ADDENDUM NO. 2

PROJECT NO. DGS C-0946-0012 PHASE 006

PROJECT TITLE - PA State Museum & PHMC Tower - Infrastructure Upgrades and Renovations

Design Resources Group Architects AIA
270 Davidson Ave, Suite 303
Somerset, NJ, 08873

SCALE 1/8" = 1'-0" PHMC TOWER - FLOOR SEVENTEEN - BASE BID 1 17.1

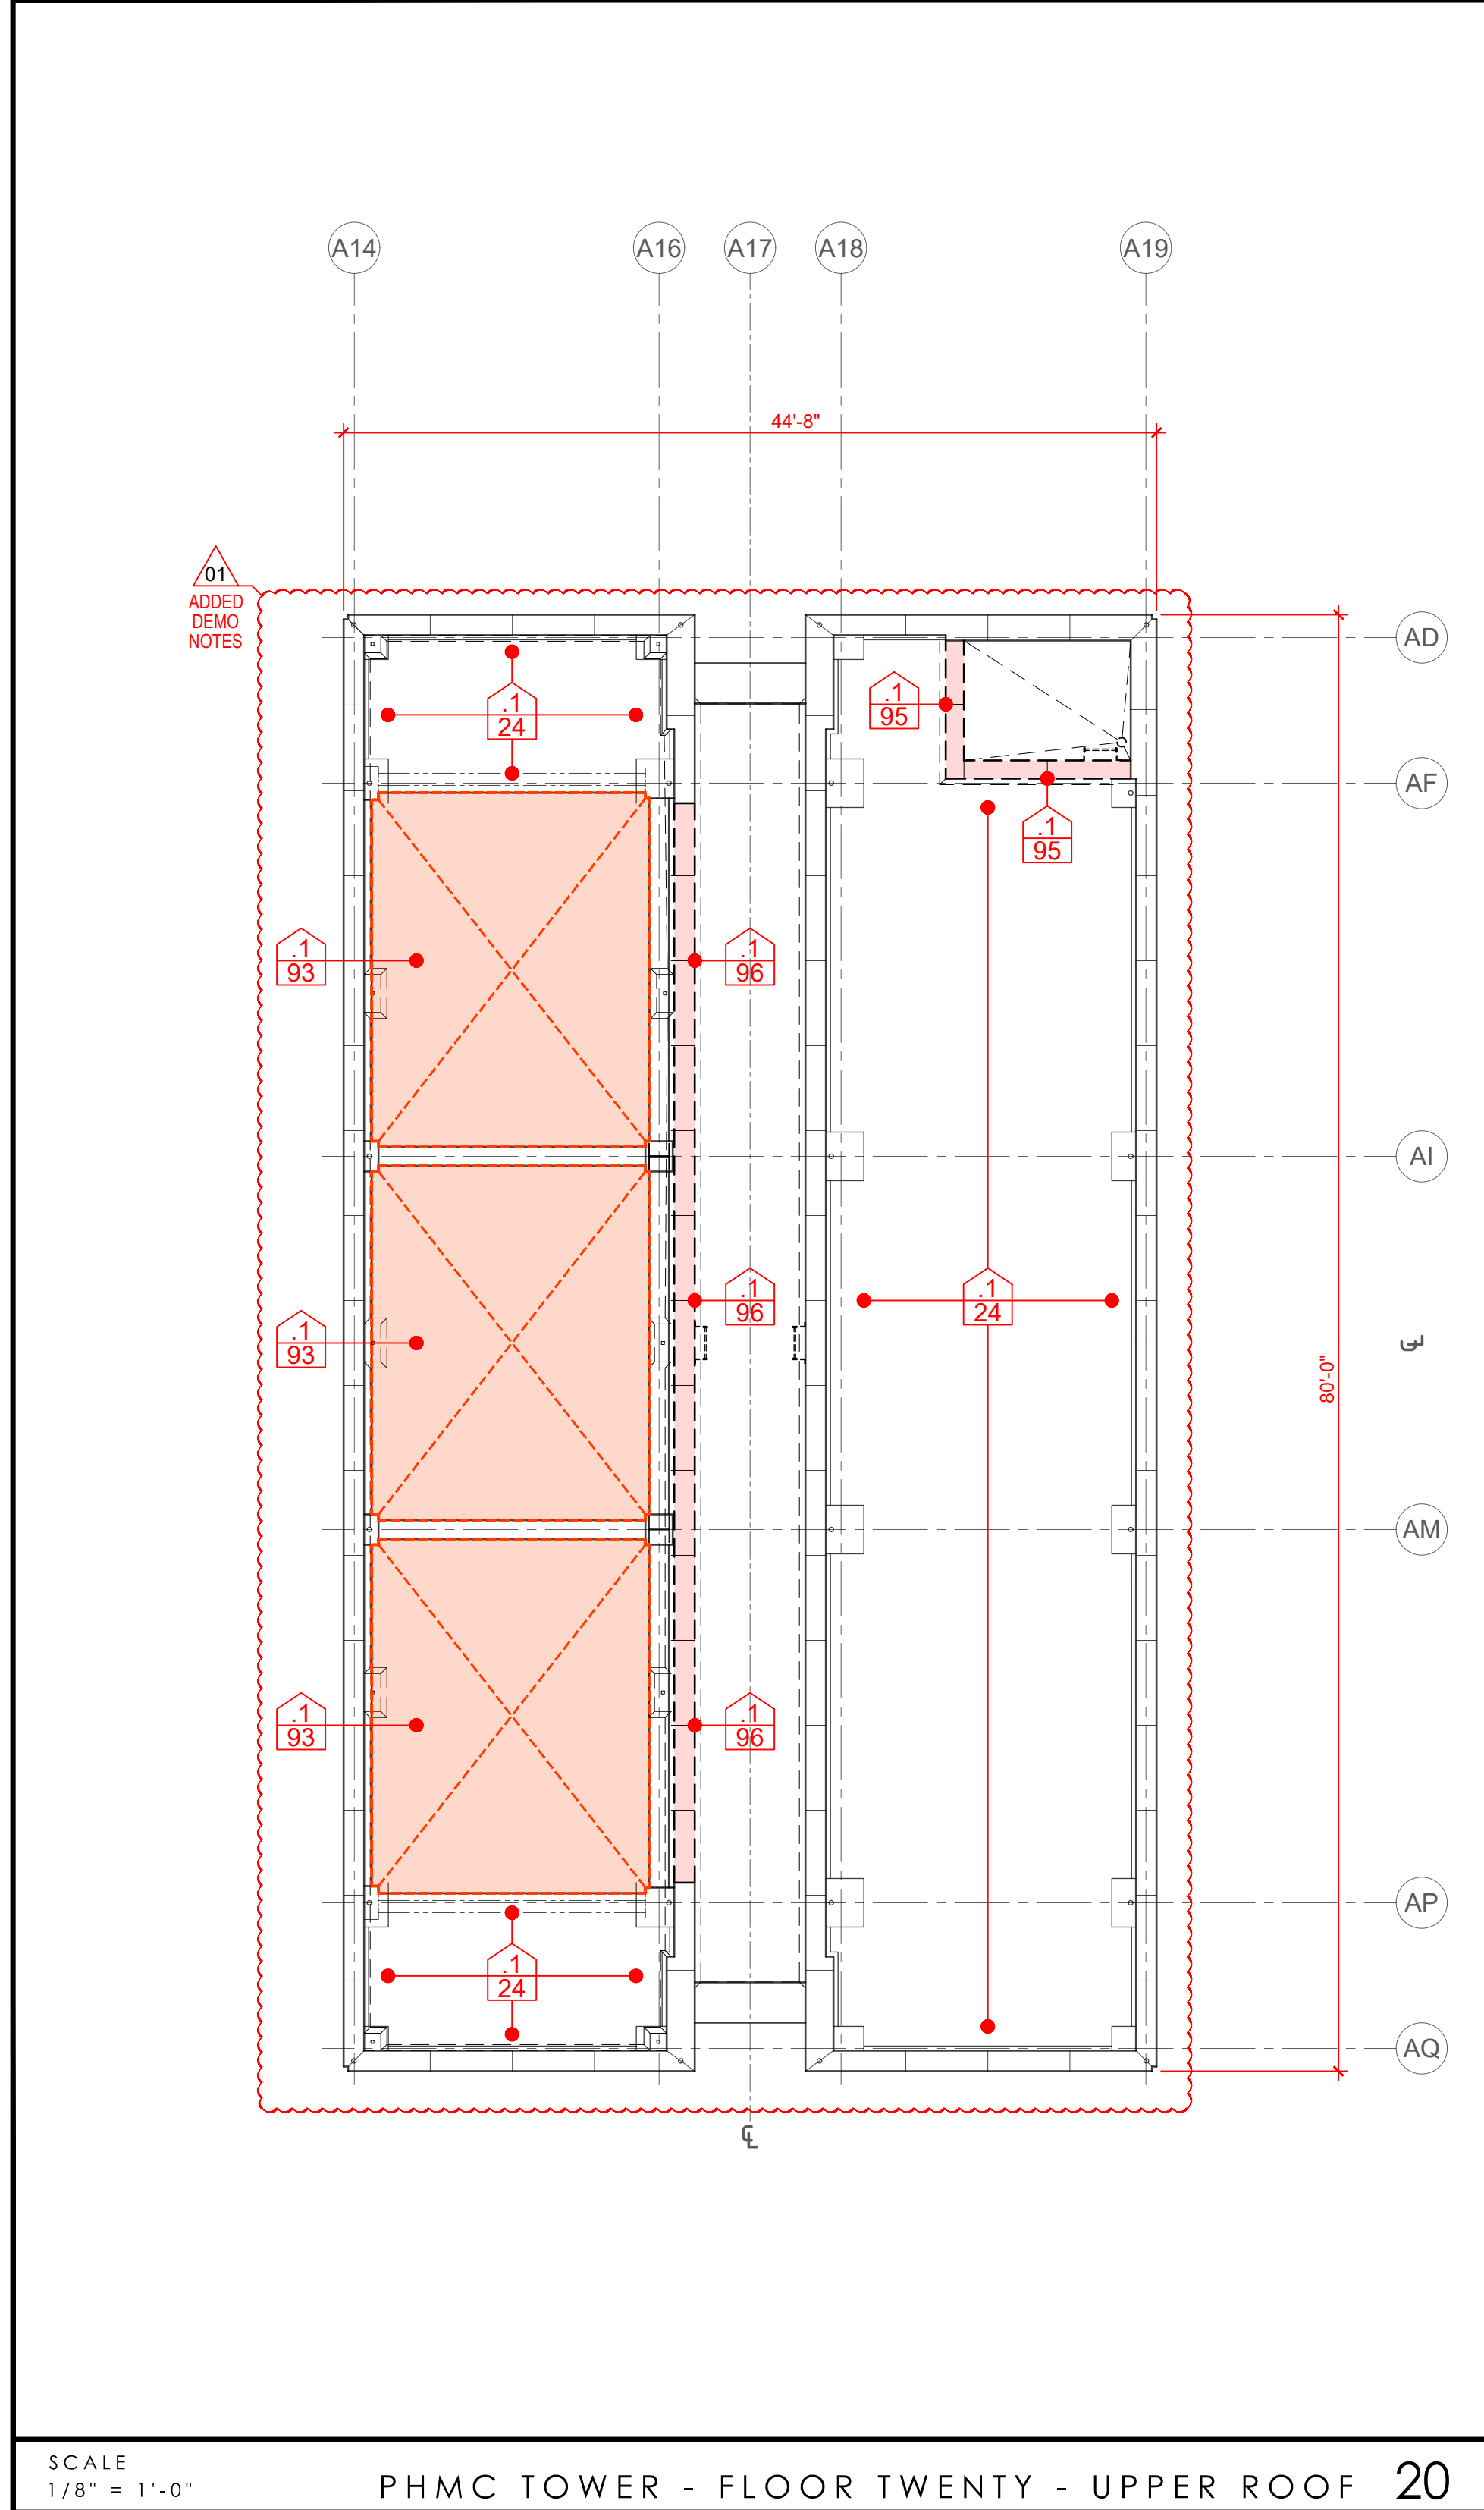
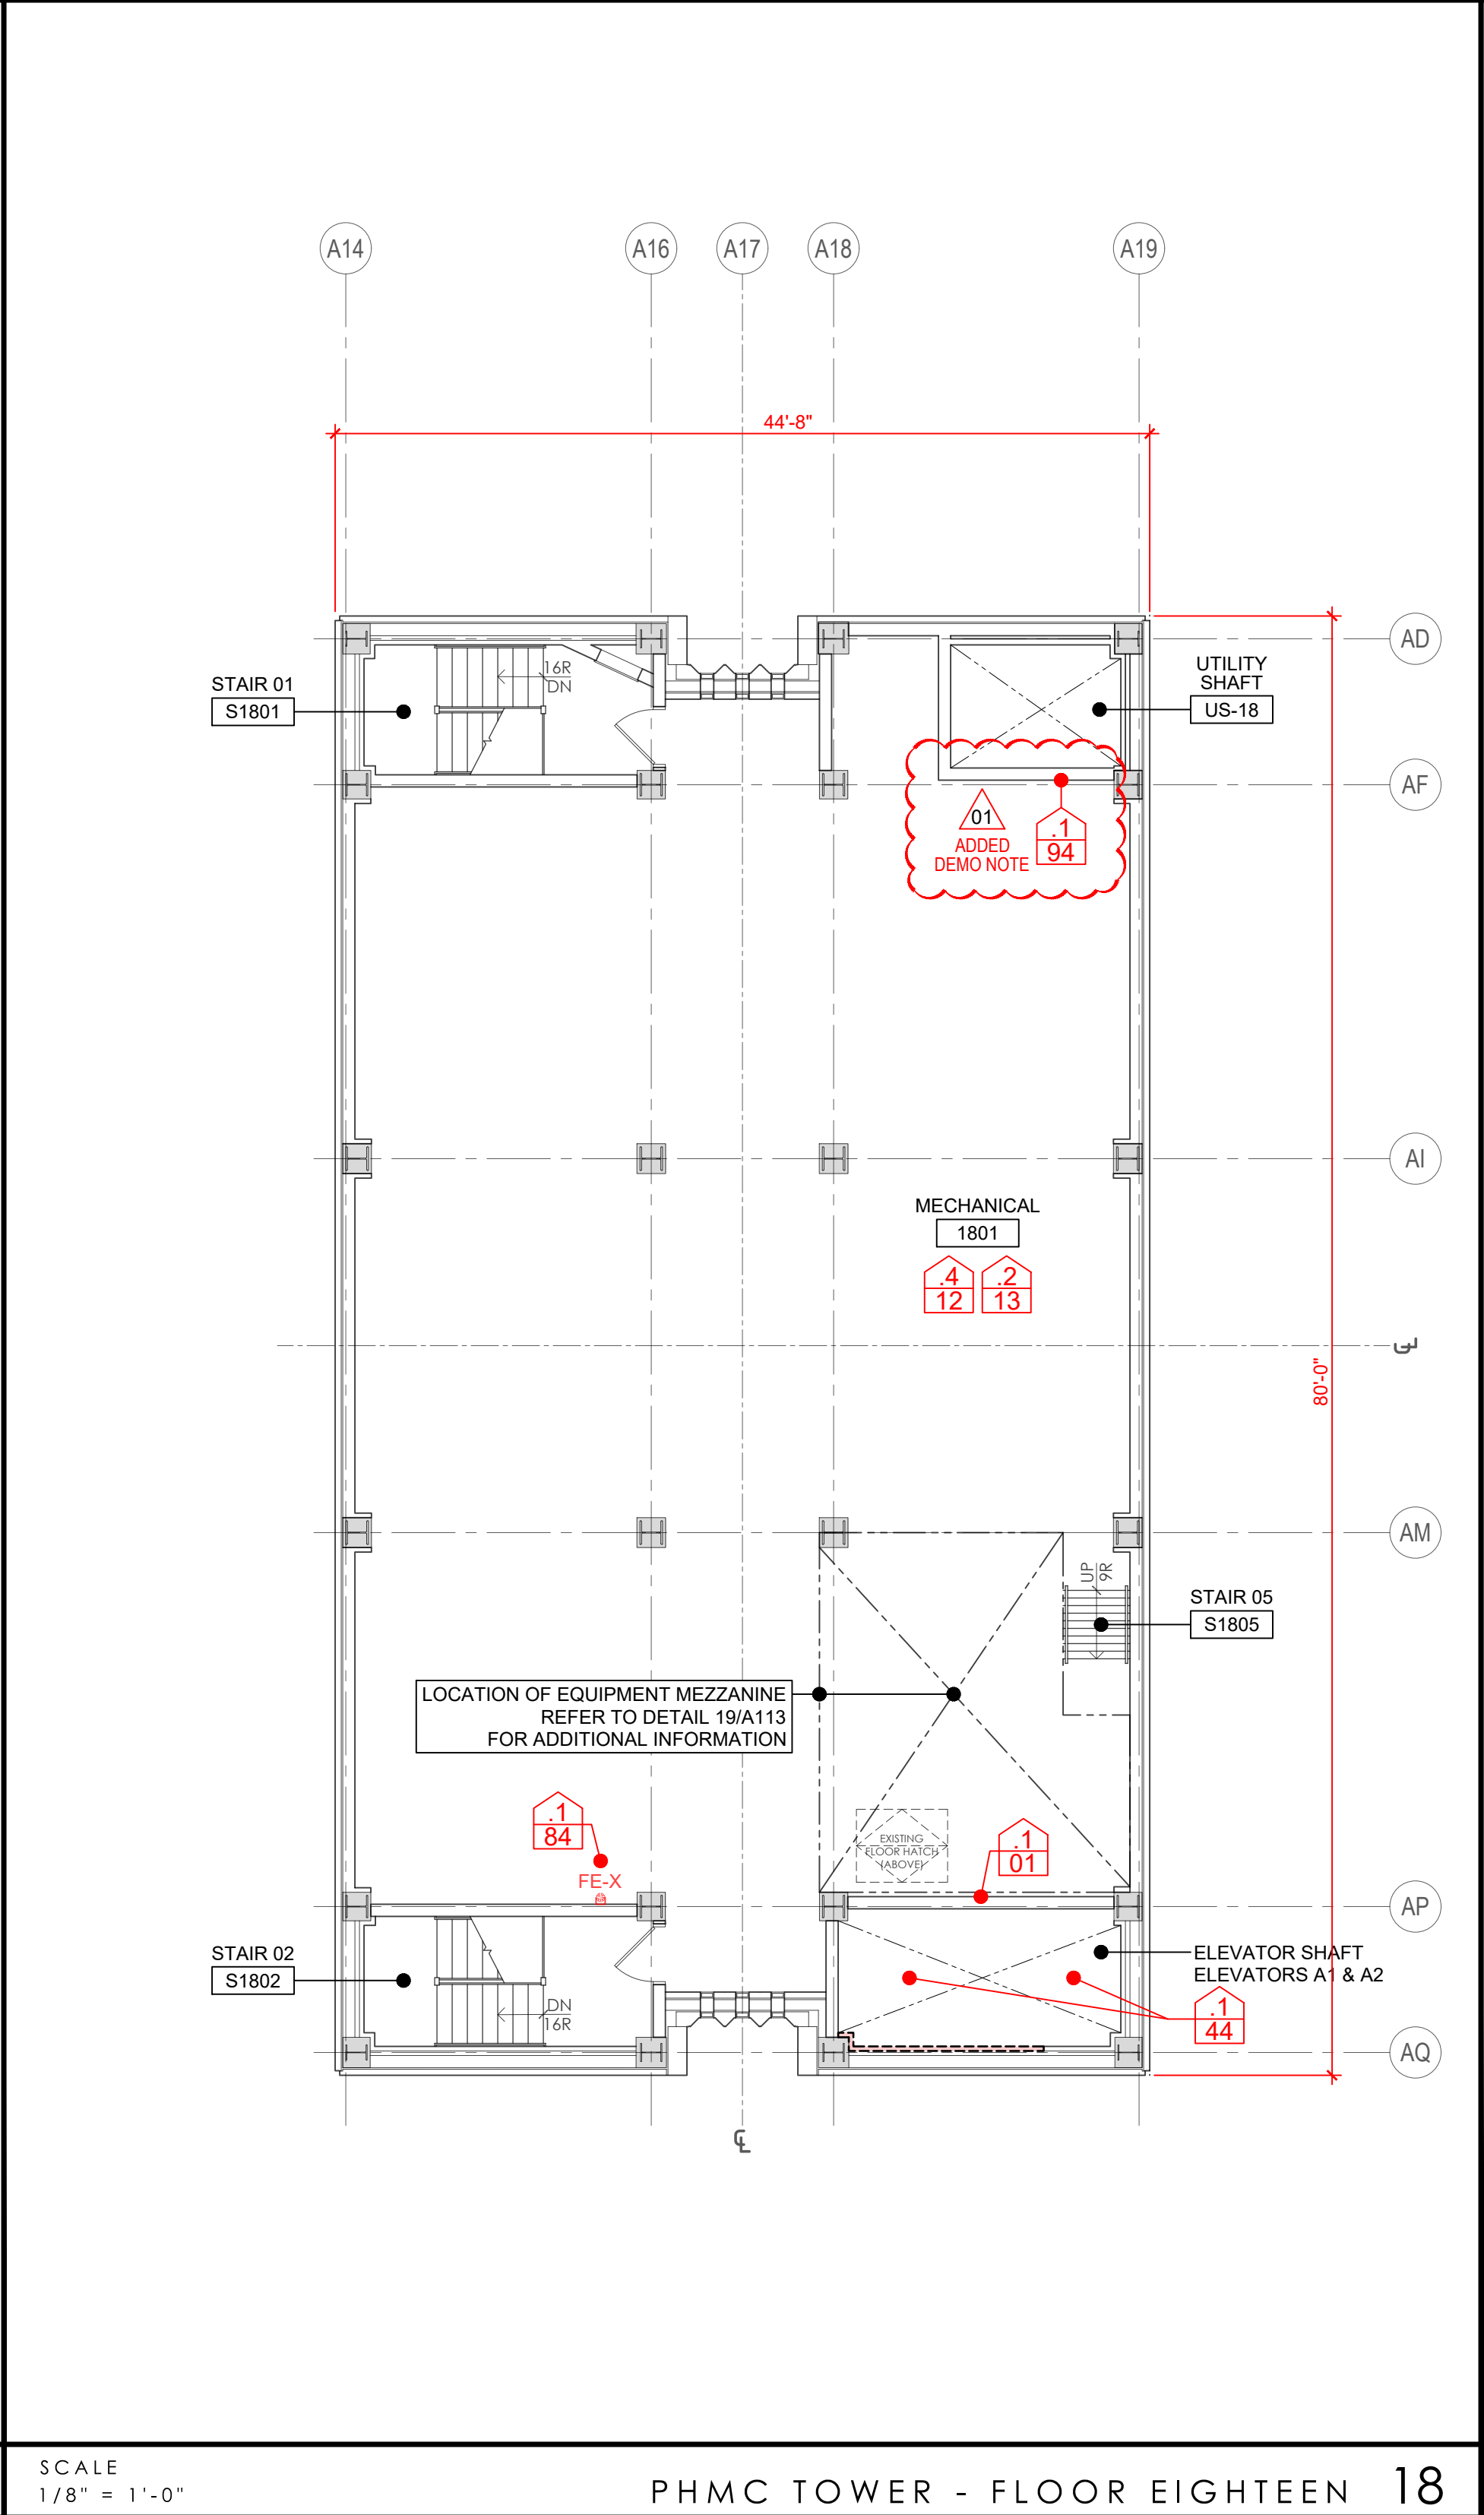
Item 13 - Drawing AD113 - At Plan 17.2, at Demo Note .1/23, deleted note reading "TYPICAL ABOVE" and added note "TYPICAL BELOW."

Item 14 - Drawing AD113 - At Plan 18, at the upper right corner, replaced Demolition Note .1/01 with .1/94.

Item 15 - Drawing AD113 - At Plan 18, at the upper right corner, added Demolition Note .1/91 covering removal of slab inside of shaft at 18th floor level.

Item 16 - Drawing AD113 - At Plan 19, added notes to show the extend of demolition of the west portion of the low roof.

Item 17 - Drawing AD113 - At Plan 20, added Demolition Keynotes.
